Notice of Intent Application: Additional Information
32 Norwood Street
Boston, Massachusetts
Ardent file ECLP-1521

Re: Notice of Intent Application: Additional Information
32 Norwood Street
Boston, Massachusetts
Ardent ECLP-1521

Responses to comments from the March 2, 2022 Conservation Commission review

PROPOSED PLOT PLAN 32 NORWOOD STREET DORCHESTER, MA FOR 28 NORWOOD LLC	
CIVIL ENVIRONMENTAL CONSULTANTS LLC 8 OAK STREET PEABODY, MA 01960 (978)531-1191	
SHEET NO: 1 OF 1	DATE 2/3/2022 JOB NO: 3868 DRAWN BY: L.J.B.

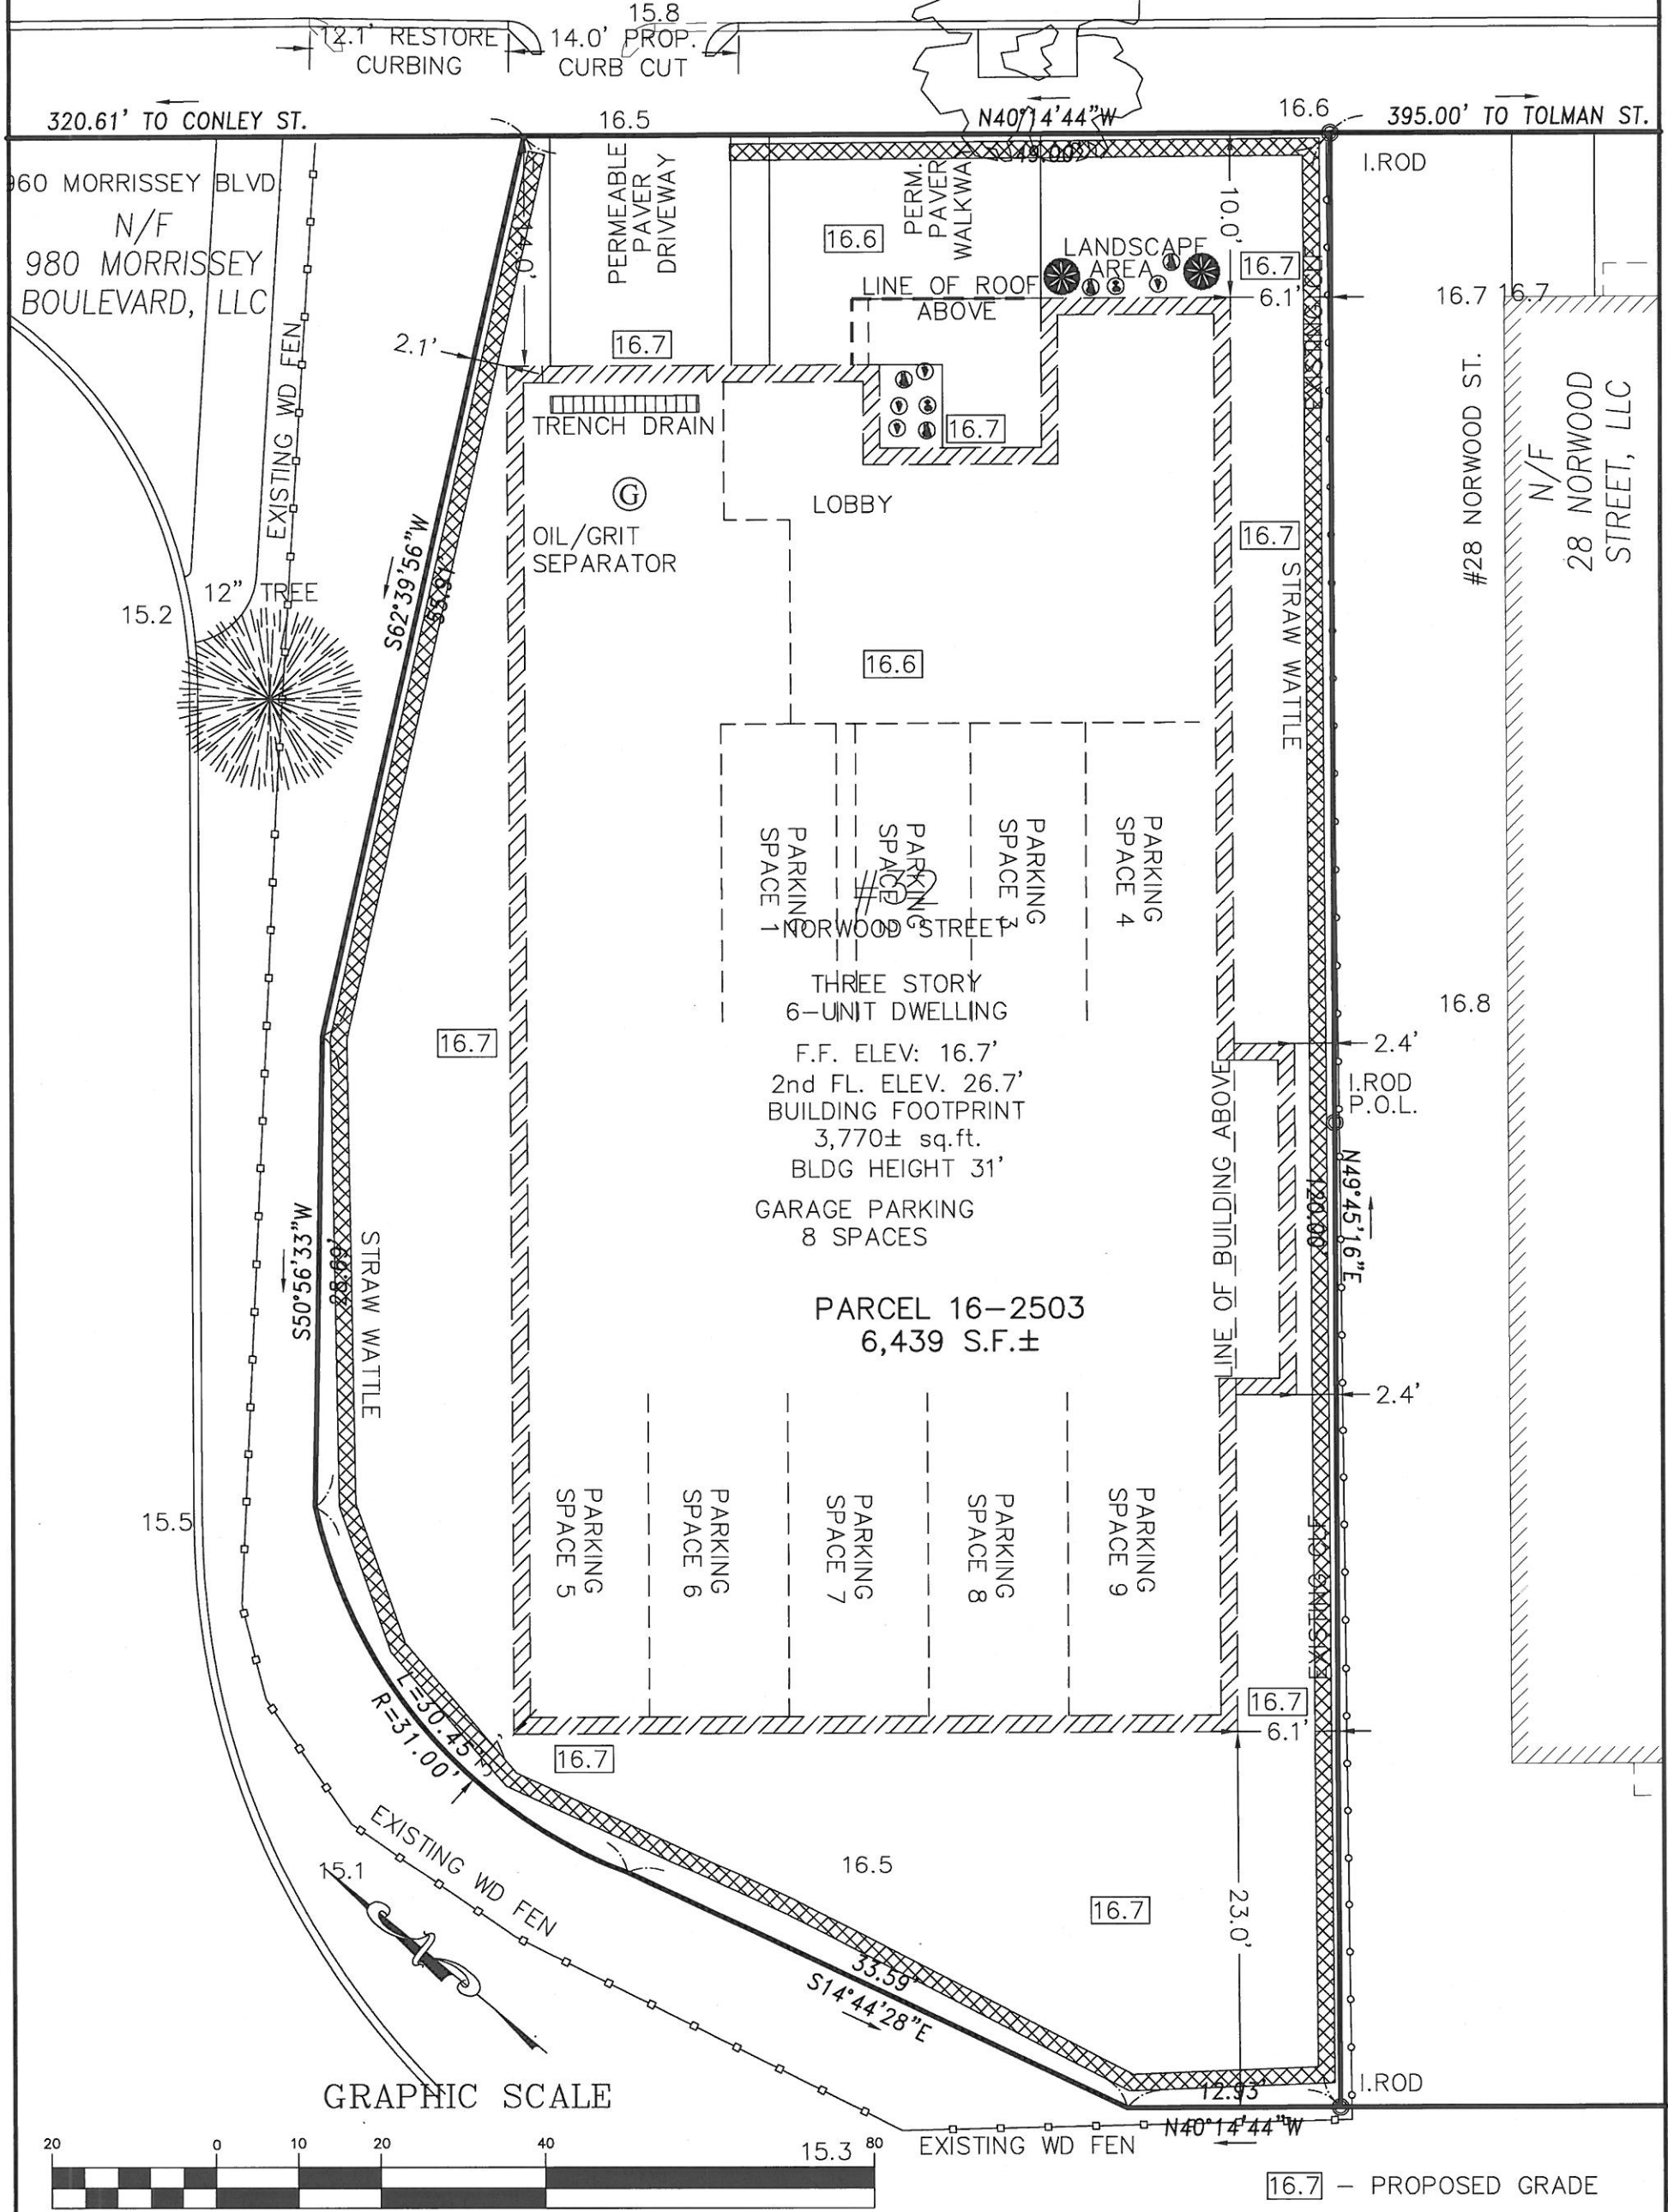
- *The FFE listed on the Climate Resiliency Checklist does not match the FFE shown on the plan set. Please make sure to differentiate between the proposed FFE and LFE in both locations.*

- Updated on the checklist.
- *Additionally, I could not match the proposed site high listed on the Climate Resiliency Checklist with the elevations on the proposed conditions plan.*

- The site high has been updated on both the proposed conditions plan and climate resiliency checklist (16.7').
- *The plan set does not show the elevation/extent of the floodplain.*
 - Note added to the proposed plot plan indicating that the entire property is located in the 100-year floodplain (Zone AE).
